NO. RFT484/125  
SUPS.DS.

Compact Filter Element Type, ProBran® PTFE membrane that meets the H13 requirement for EN1822 testing, 67 pleats, hard PU top and bottom, with a integral gasket.

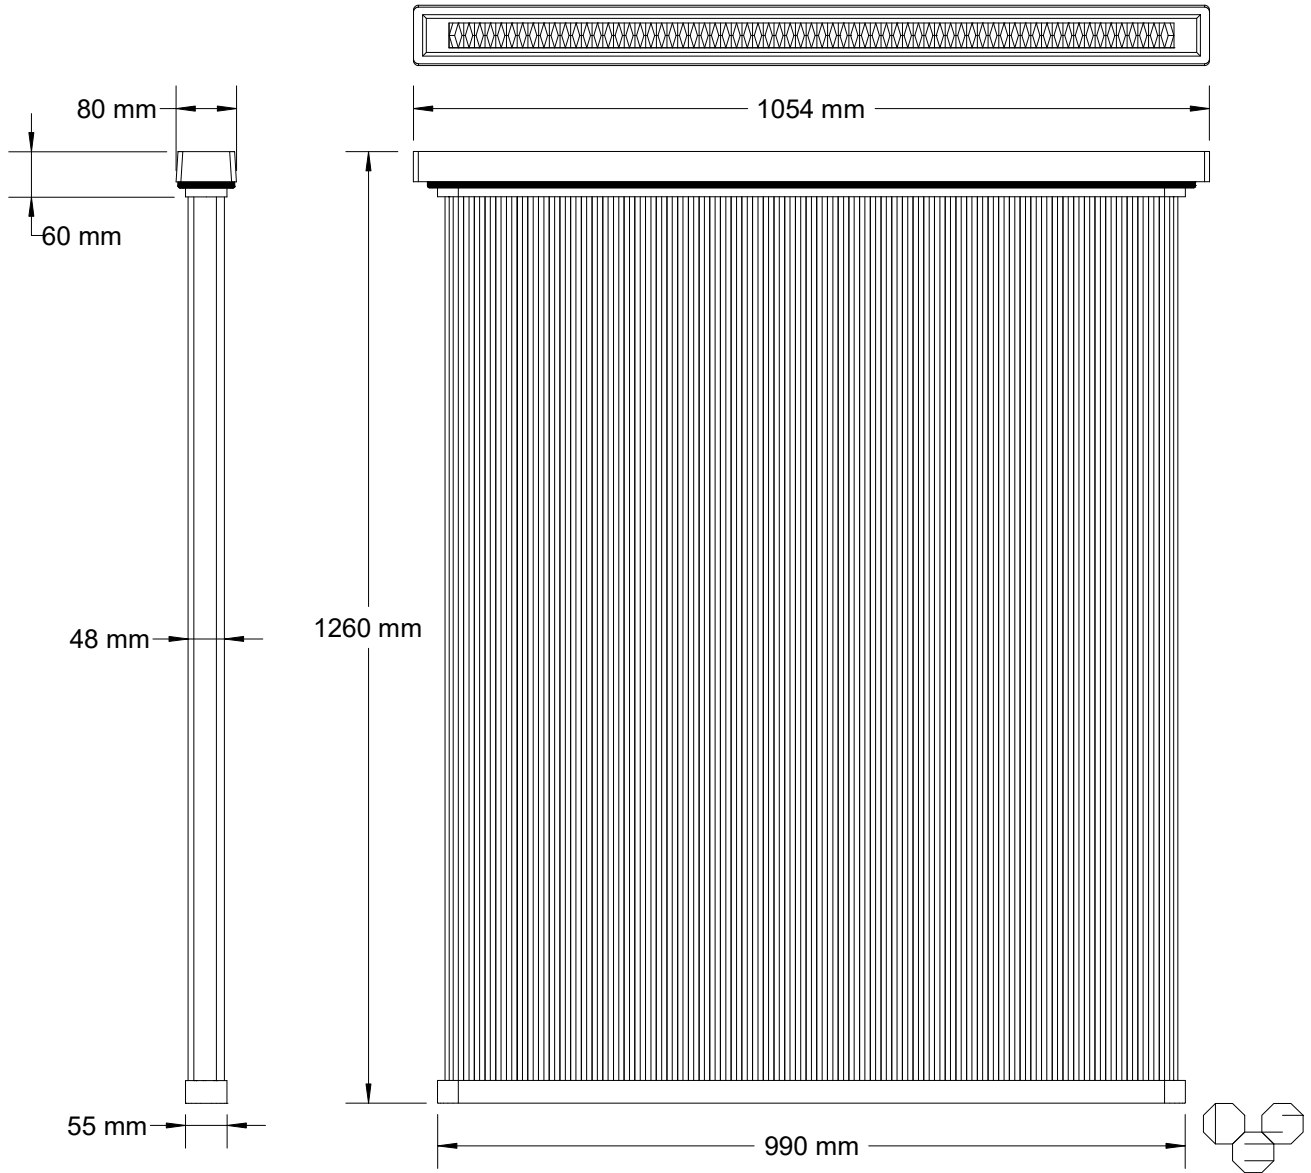
QTY.	PRODUCT	NEXT ASSY. DWG.	NO.	DESCRIPTION OF CHANGE	SCO#	DATE	BY
			0	NEW ISSUE		02/13/13	DSE
			1	Media changed from Sinbran to ProBran PTFE		04/06/20	DSE
			2				
			3				
			4

**WARNING:** if you have been using the SINBRAN filter medium (tubular shaped) you MUST reduce the cleaning air pressure setting from 6 bar down to 4 bar. Operating above 4 bar will damage the pleated filter membrane!

It is recommended that the compressed air for the cleaning/purge cycle be set at no greater than 4 bar MAXIMUM.
